SUBJECT : Hyundai ImageQuest Co., Ltd.
FCC ID: PJIL17A00000
Class II Permissive Change
Orig. Grant Date : March 29, 2005

Transmitted herewith, on behalf of Hyundai ImageQuest Co., Ltd. is an application for a Class II Permissive Change Certification of the following 17-inch LCD Monitor:

FCC ID : PJIL17A00000
Type No. : L17A00000

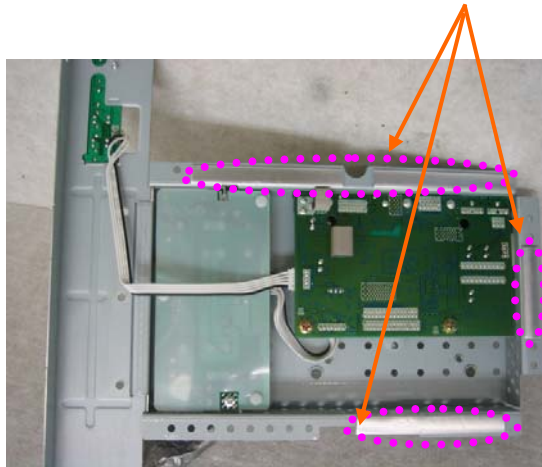
1. Attach a gasket on the main frame to contact the lcd panel

2. Attach a gasket on the main board to contact the main frame

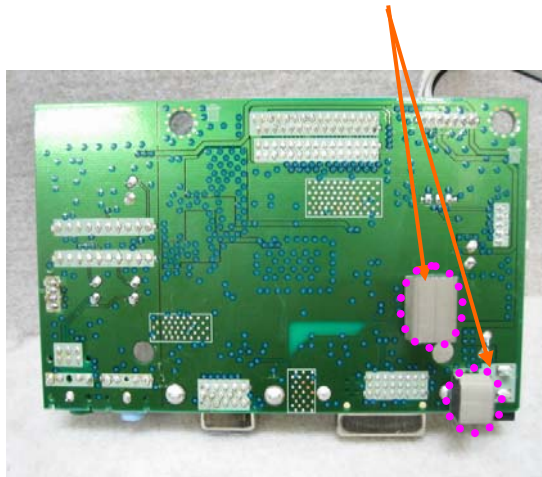
3. Attach aluminum tape on the Rear frame.
